**Bulletin Number: PS - 4 - 2010**
**Bulletin Date: July 2010**

# SERVICE BULLETIN

## Subject: Design change to F0822R, N0622R, F1222R, N0922R, F1522R and N1322R

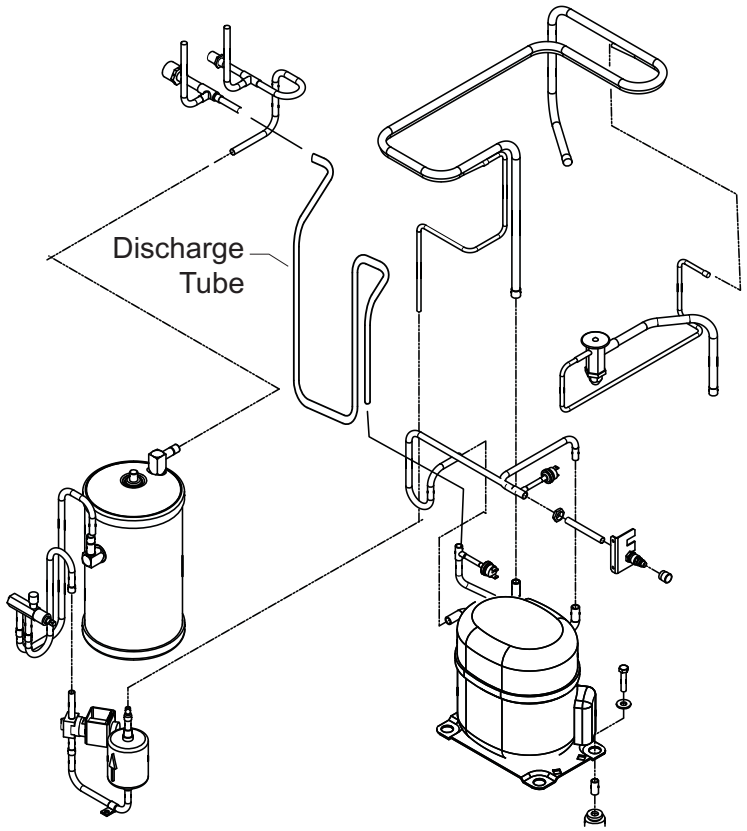
Beginning with serial number 10041320013153 the discharge tube between the compressor and the quick-connect fitting in the back of the cabinet has been changed to add an oil trap. See the illustration:

Recommendation: When changing a compressor on a unit built before the design change, order a new discharge tube and change it as well.

F1222R, N0922R, F1522R and N1322R use part number: **A39290-001**

F0822R, N0622R use part number **A39264-001**
